**From:** Raymond DeGiorgio  
**To:** Joseph Joshua  
**CC:** Arnaud Dessirieux; David M. Trush  
**BCC:**  
**Sent Date:** 2005-03-07 14:59:03:000  
**Received Date:** 2005-03-07 14:59:07:000  
**Subject:** Re:Torque Study ----- X001 Ign Cylinder rotation effort  
**Attachments:** GMX001 Lock Module Detent in RUN 20050216.ppt

# GMX001 Lock Module Detent in RUN

## ➤ Design Evaluation (Engineering and Cost)

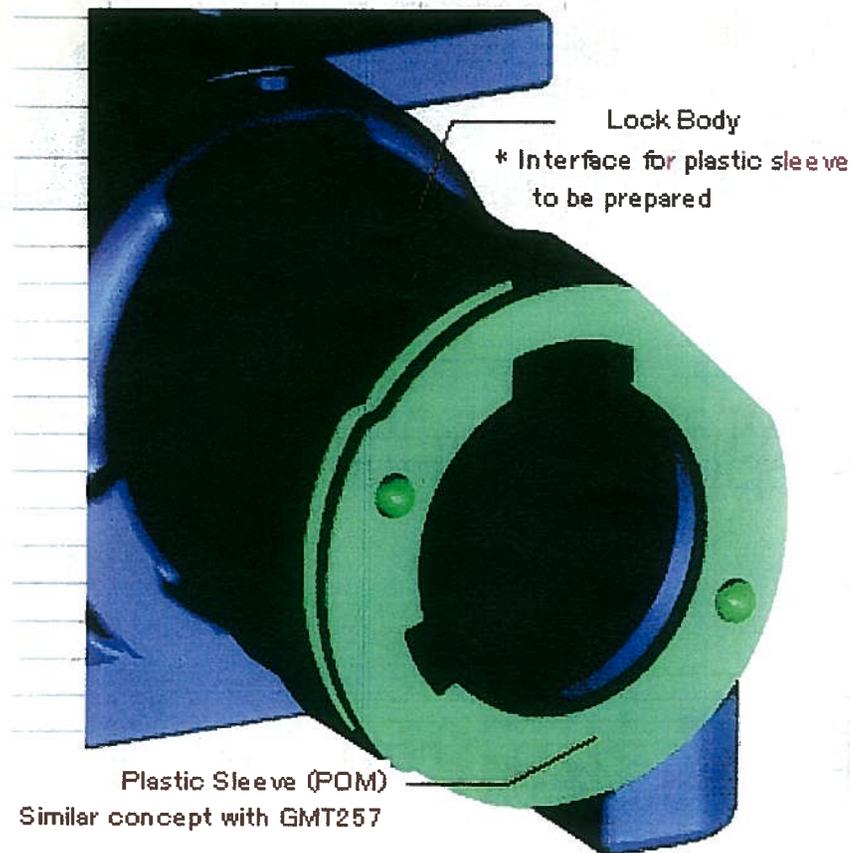
- The most preferred by supplier

<b>Engineering</b>		<b>Cost &amp; Timing</b>		
<b>Benefits</b>	<b>Concerns</b>	<b>Piece Cost Increase</b>	<b>Tooling</b>	<b>Lead Time</b>
No interface tuning required (between lock housing and cylinder)	-A few new components are needed - Torque specification needed by supplier	\$0.5716	179143 (new tooling)	About 1 year

## ➤ Design Evaluation

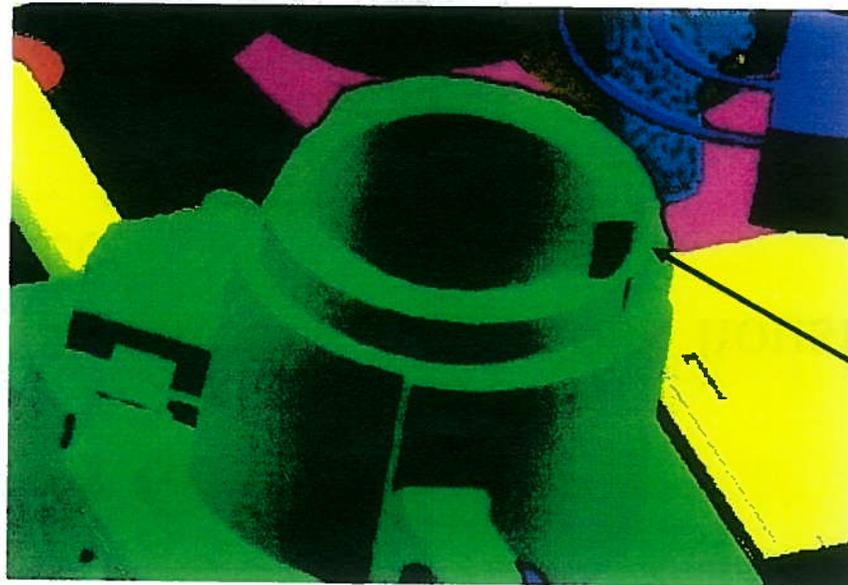
- Main concern with trimming of the lock housing to accommodate plastic sleeve

Material thickness  
creates concern for  
GMX001 lock hosing

- Adding spring loaded pins to the lock housing:

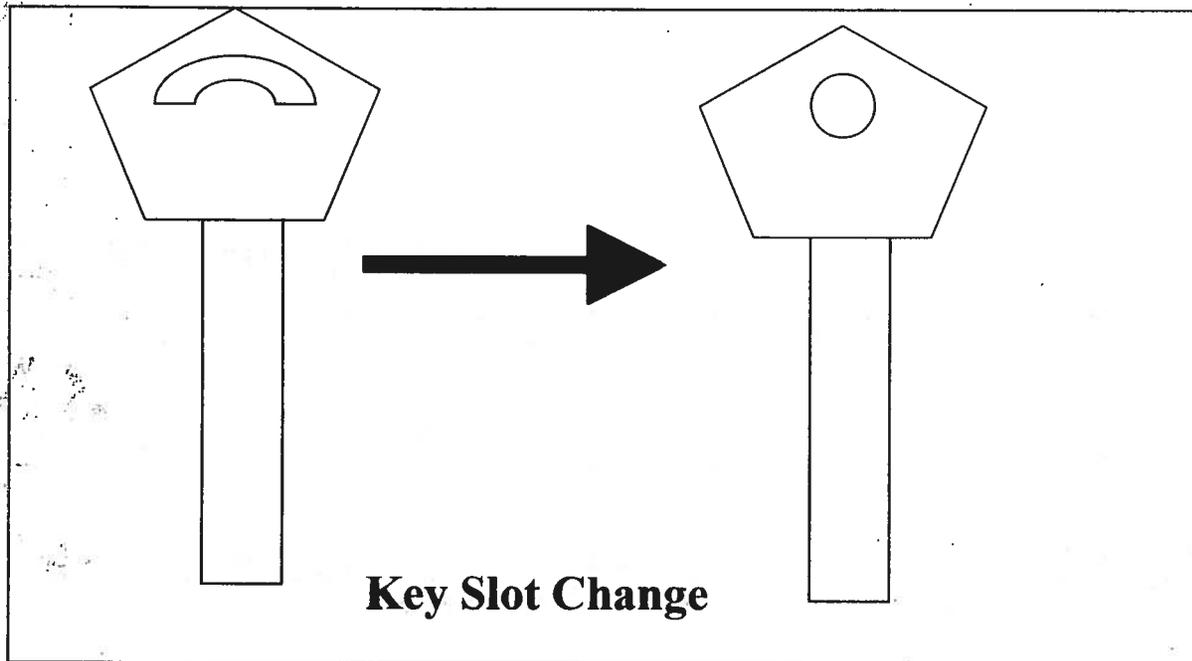
- Main concern with complexity in warranty.
- Ruled out by lock housing supplier
